WOLF CREEK GENERATING STATION, UNIT NO. 1
ENVIRONMENTAL REPORT OPERATING LICENSE STAGE

REVISION 2
INSTRUCTIONS FOR INSERTING REVISION 2

FIGURE 2.1-6
SITE FEATURES

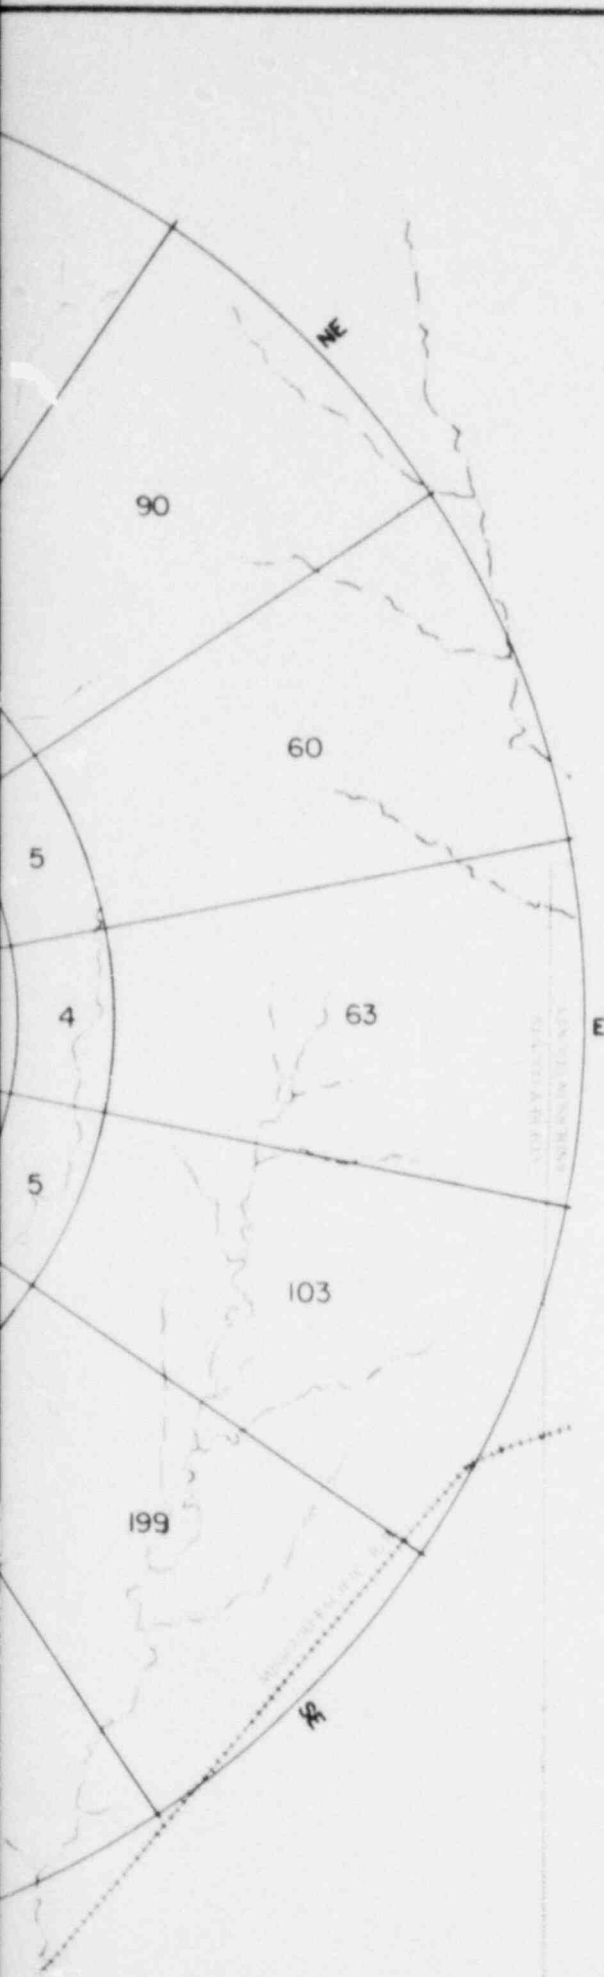
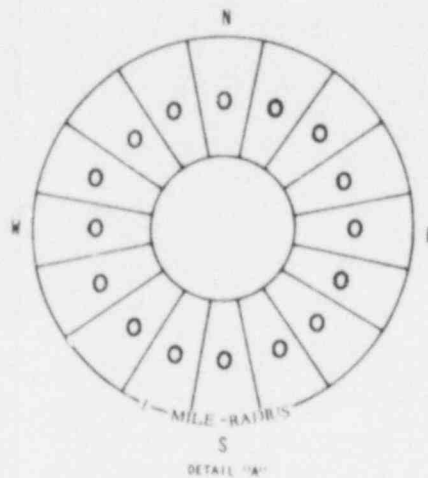
R290.8 The site boundary was changed in a few minor ways between that described in the Environmental Report Construction Permit Stage (ER[CPS]) and the Environmental Report-Operating License Stage (ER[OLS]). Figure 2.1-8 of the ER(CPS) and 2.1-6 of the ER(OLS) should be compared to show the changes. The changes resulted in less property being purchased for WCGS proper. The nominal acreage within the site boundary in the ER(CPS) was 10,500 acres and the actual amount purchased was 9,818 acres. The specific changes are:

- Sections 13 and 24, T21S-R15E -- Boundary moved east to section line;
- Section 30, T21S-R16E -- Boundary moved north to half-section line (See revised ER(OLS) Figure 2.1-6);
- Section 17, T21S-R16E -- Boundary excludes NW 40 acres (See revised ER(OLS) Figure 2.1-6);
- Section 9, T21S-R16E -- Boundary moved west to section line; and
- Section 36, T20S-R15E -- Boundary moved west to follow lake contour.

Figure 240.8-1
Flow-Duration Curve - Daily
Flow of Neosho River at
Burlington

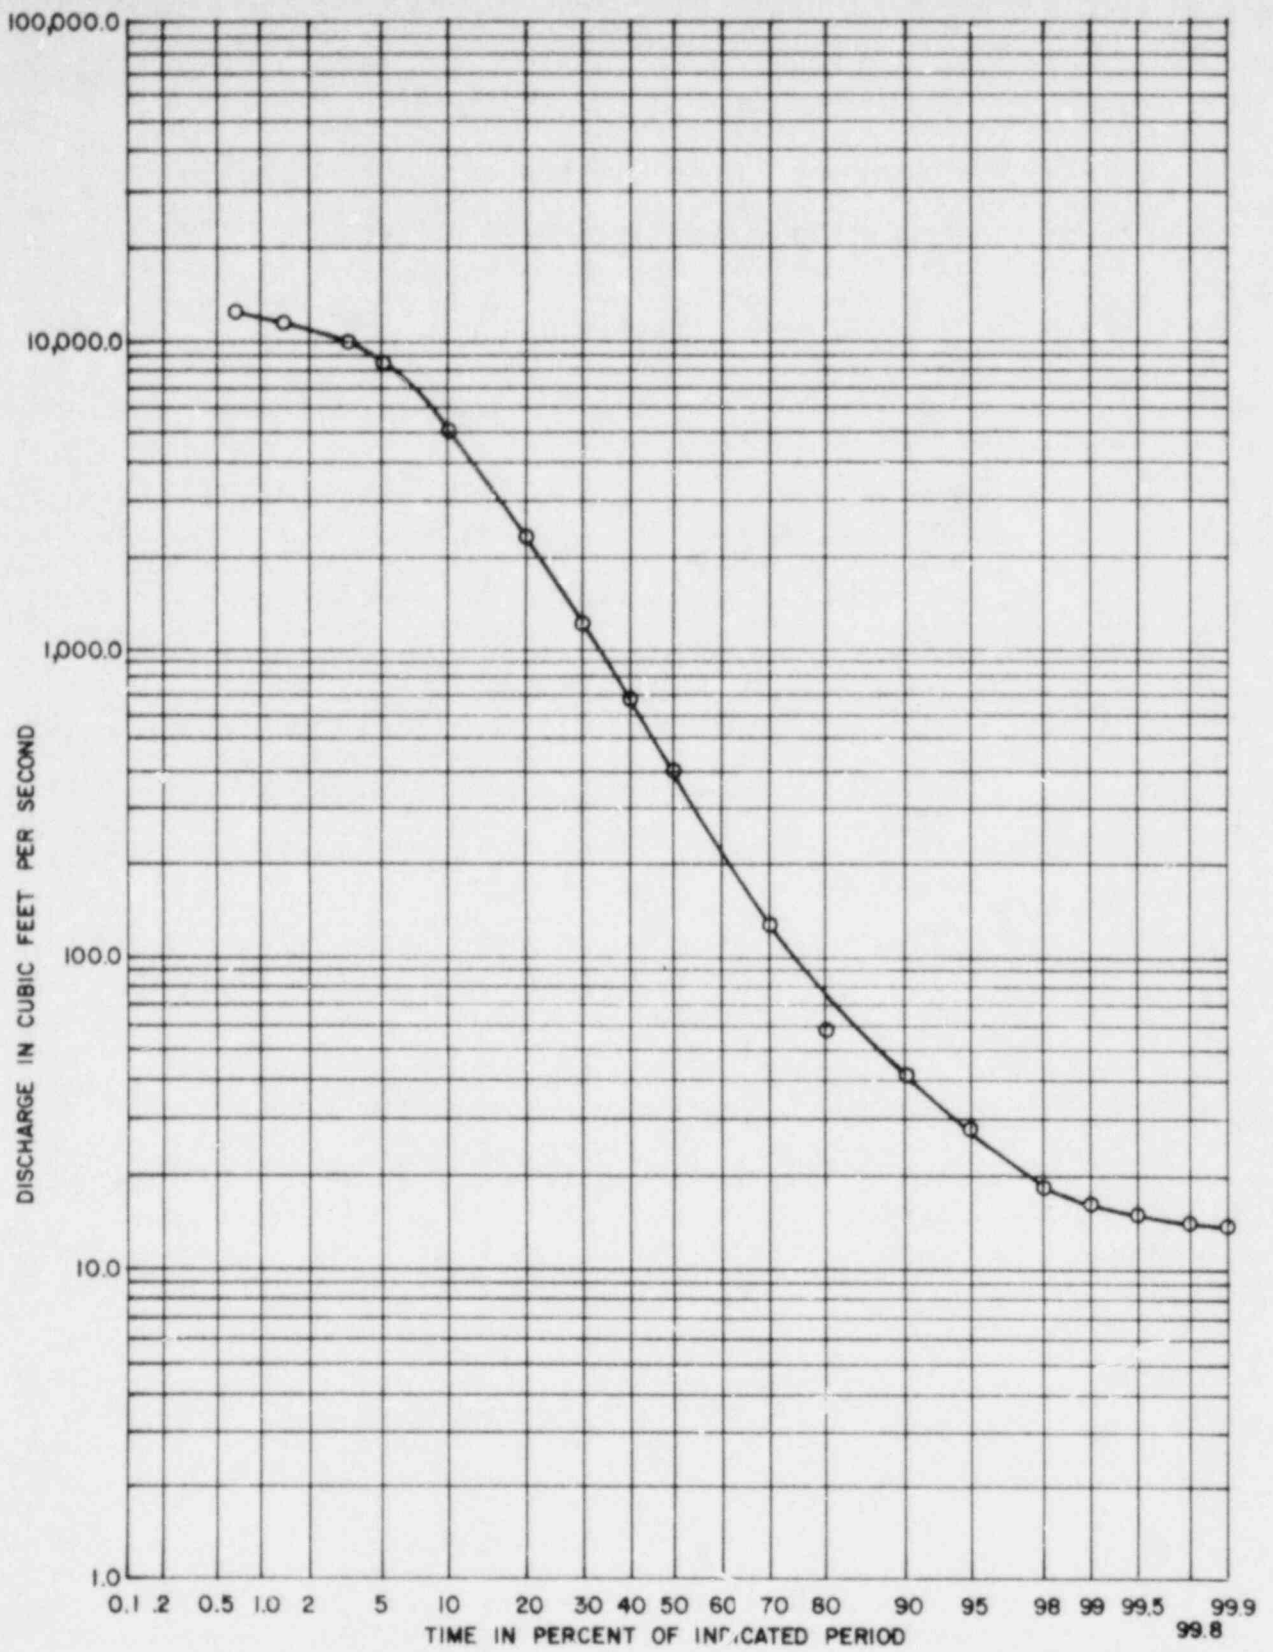
Q240.8
(ER)
(2.4)

Provide a flow-duration curve for the Neosho River at Wolf Creek reflecting regulation by the John Redmond Reservoir. Also provide an estimate of the 7 consecutive day once in 10 year low flow for the river at Wolf Creek under the same conditions. Discuss the effect of plant operation on these parameters. Provide in your discussion your assumptions regarding reservoir release rates and plant withdrawals.

R240.8

The nearest U.S. Geological Survey gaging station on the Neosho River downstream of John Redmond Reservoir and near the confluence of Neosho River and Wolf Creek is at Burlington, Kansas. This gaging station at Burlington, Kansas, is approximately five miles downstream of John Redmond Reservoir and the confluence of Neosho River and Wolf Creek is approximately 4 miles downstream of this gaging station. The flow-duration information for Neosho River at Burlington, Kansas, for the period October 1964 to September 1979 is presented in Figure 240.8-1. The 7-day 10-year low flow for the same period is 17.3 cfs.
